# Town of Milford Meeting Notice

**Board or Commission: Conservation Commission**

**Date and Time of Meeting: Wednesday September 16, 2020 at 7.00 P. M**

TO: Mr. Michael Giampietro, Chairman – Conservation Commission  
FROM: Michael Dean, P.E. *MD*  
DATE: September 11, 2020  
SUBJECT: **158 East Main Street (formerly #154) – Kevin Meehan – Hyundai Dealership  
Request for Certificate of Compliance – DEP File # 223-526**

AS-BUILT  
 PLAN OF LAND  
**12 GORDON DRIVE**  
 IN  
**MILFORD, MA**  
 SCALE: 20 FEET TO AN INCH  
 DATE: AUGUST 11, 2020

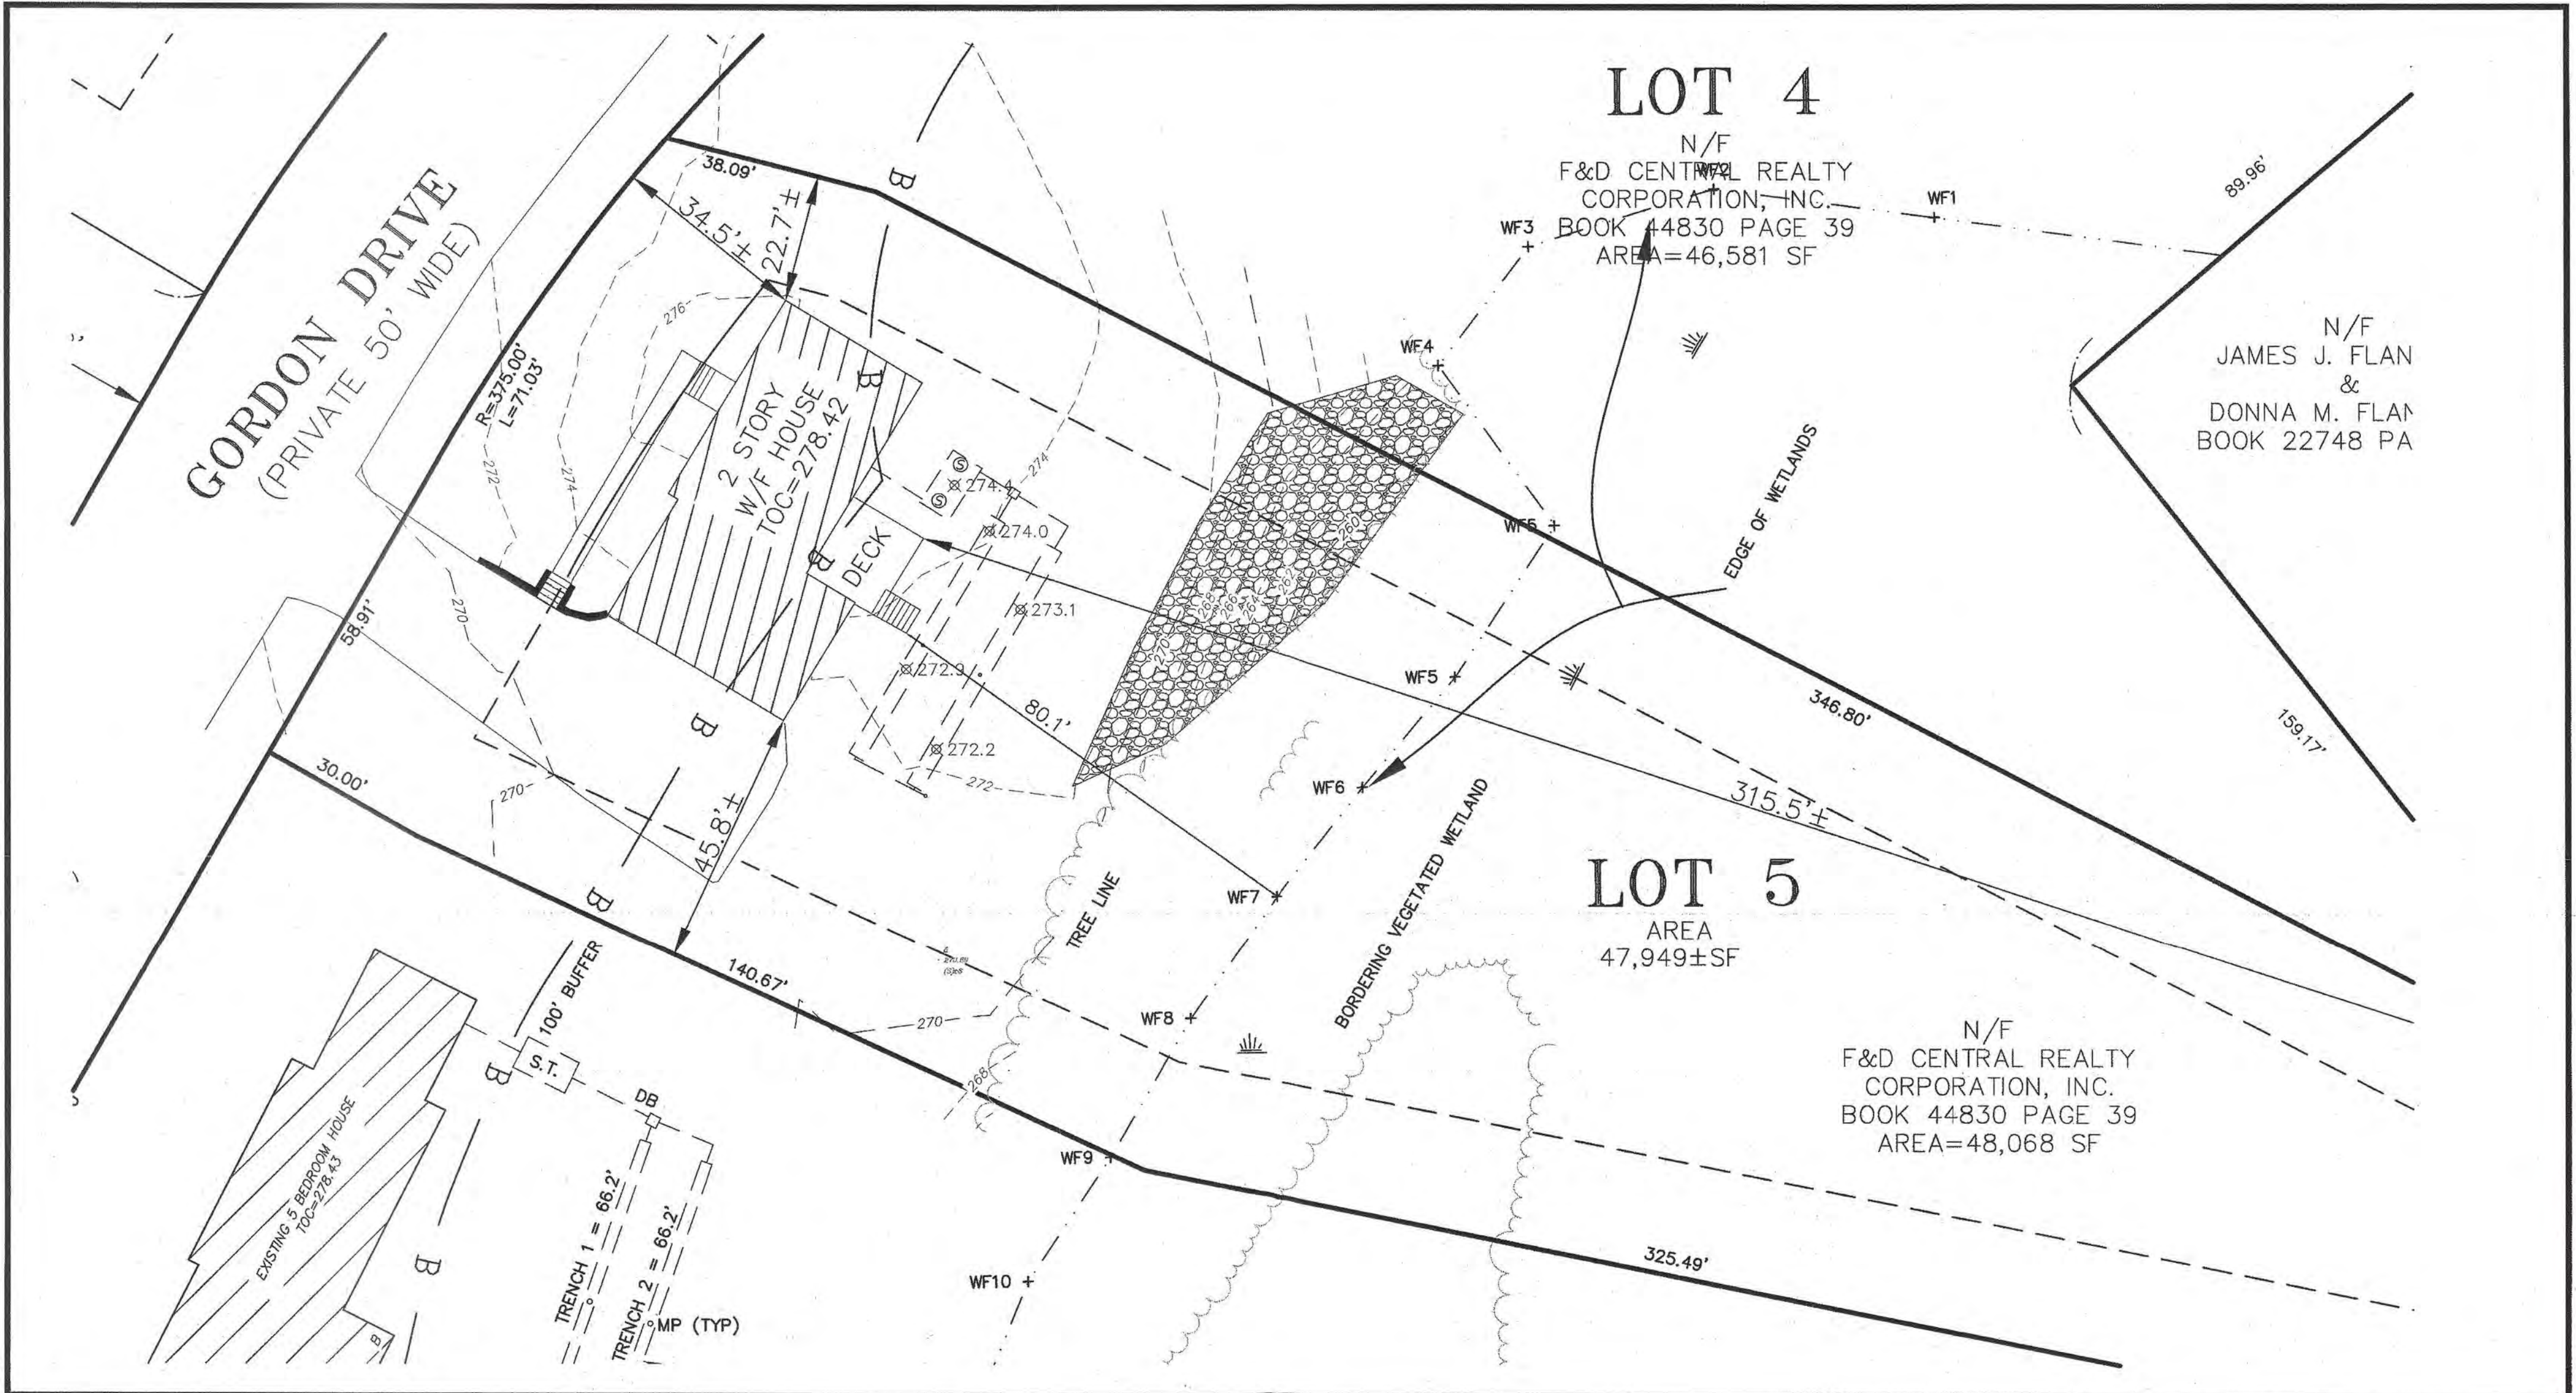
The plan does not show that there have been any wetland pins (iron rods with caps) set at the edge of the wetlands / flag locations.

Following a site inspection and reviewing the submitted documents I recommend that the wetland pins be set prior to the issuance of a Certificate of Compliance.

BENJAMIN MOORE  
 SITE  
 AS-BUILT  
 #49 SUMNER STREET  
 IN  
 MILFORD, MA  
 SCALE: 40 FEET TO AN INCH  
 DATE: AUGUST 13, 2020

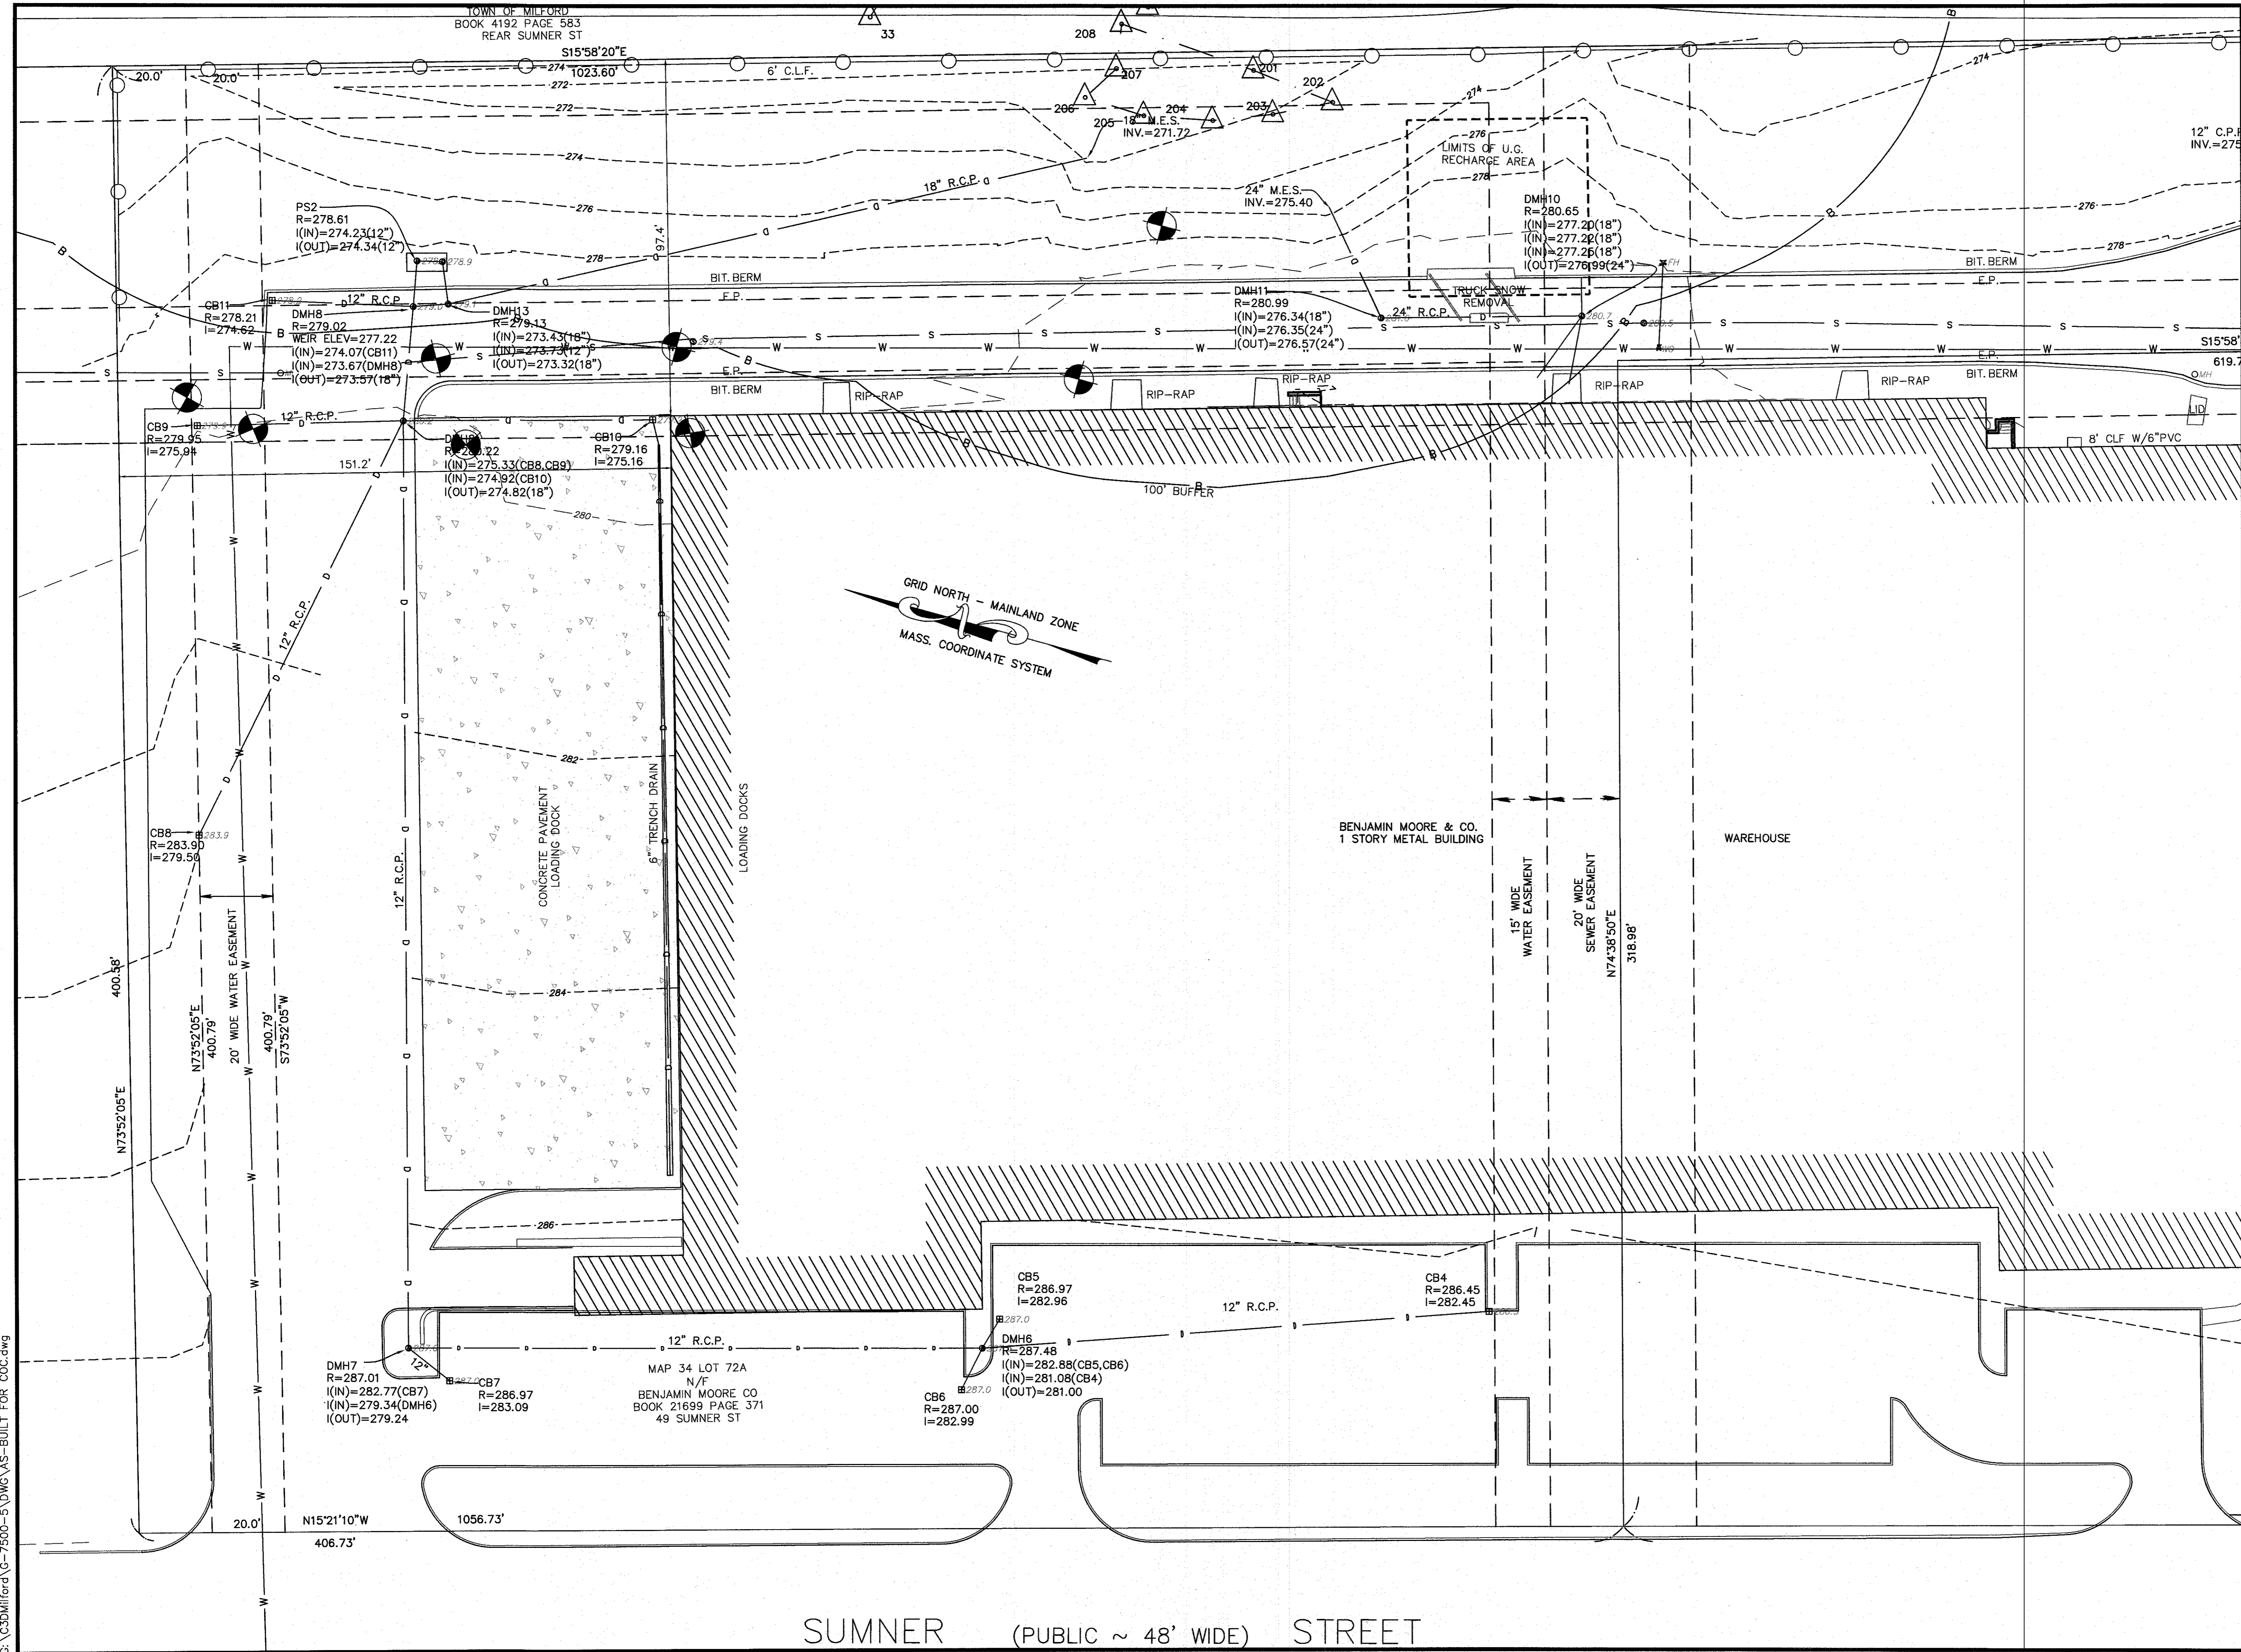
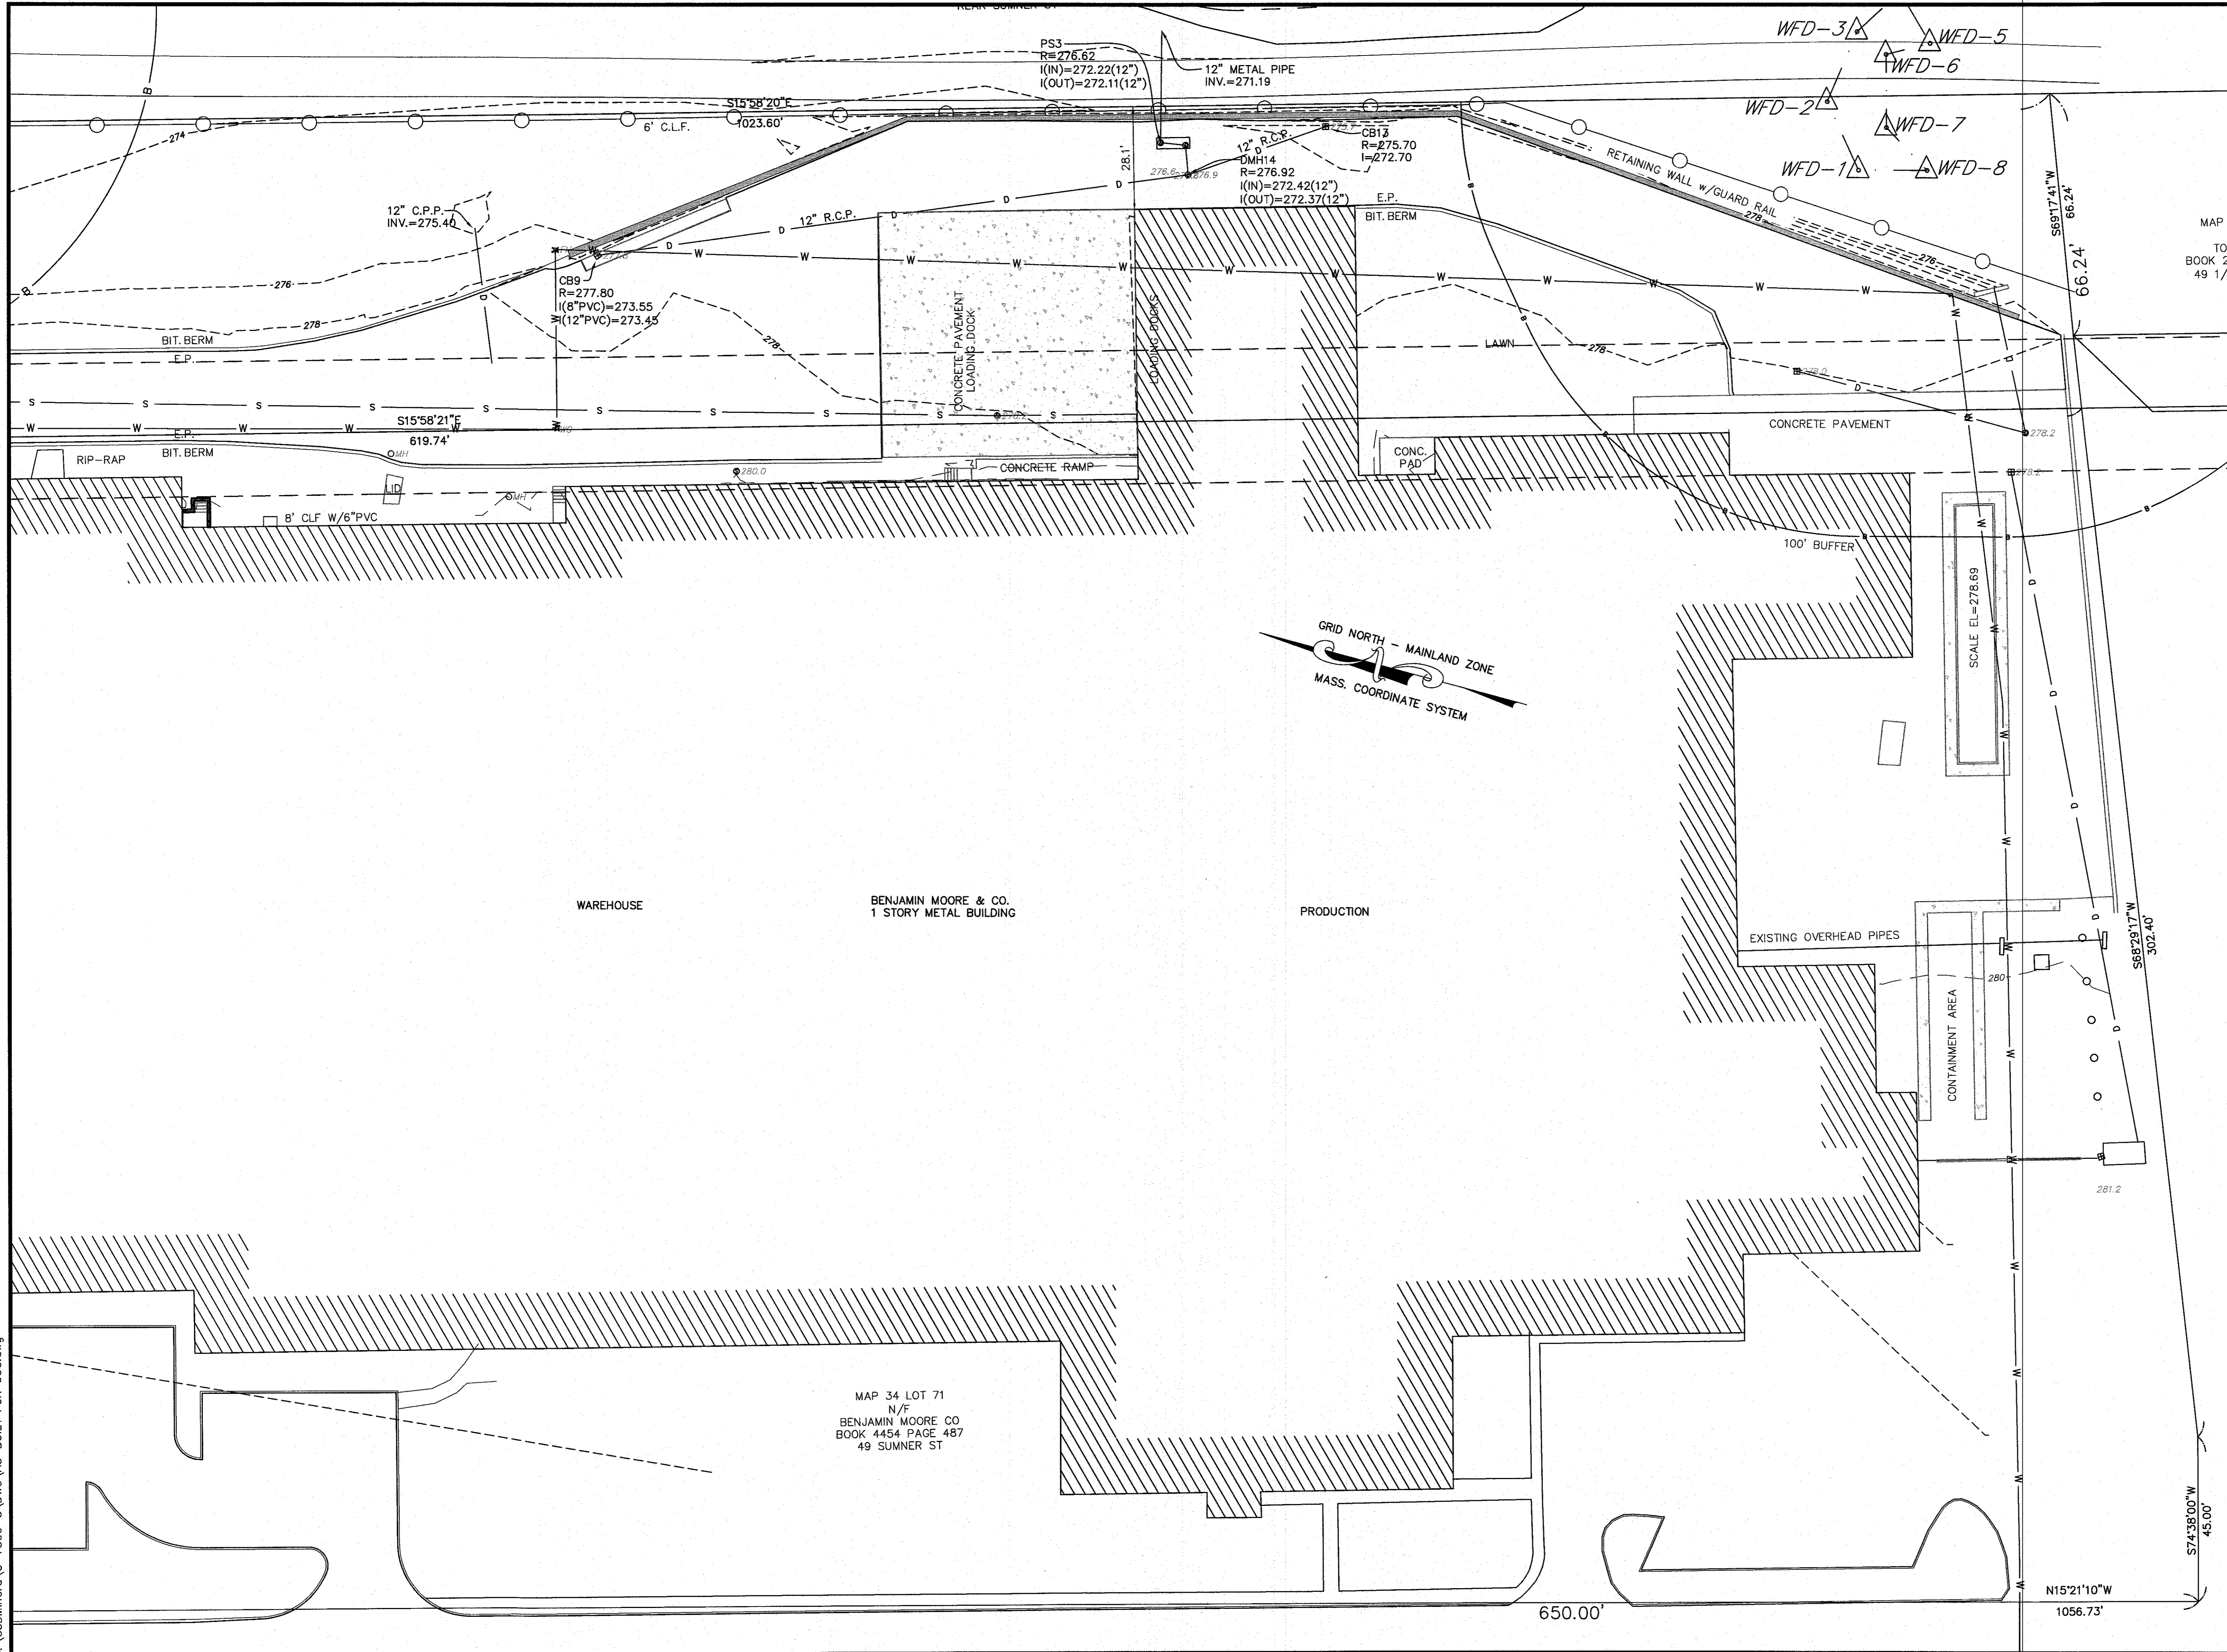
1. This office has not received “stamped” As-Built Plans to date.
2. The As-Built Plans that we did receive via email (pdf’s) do not show the drainage in front of the building (near Sumner Street), that is associated with this project.
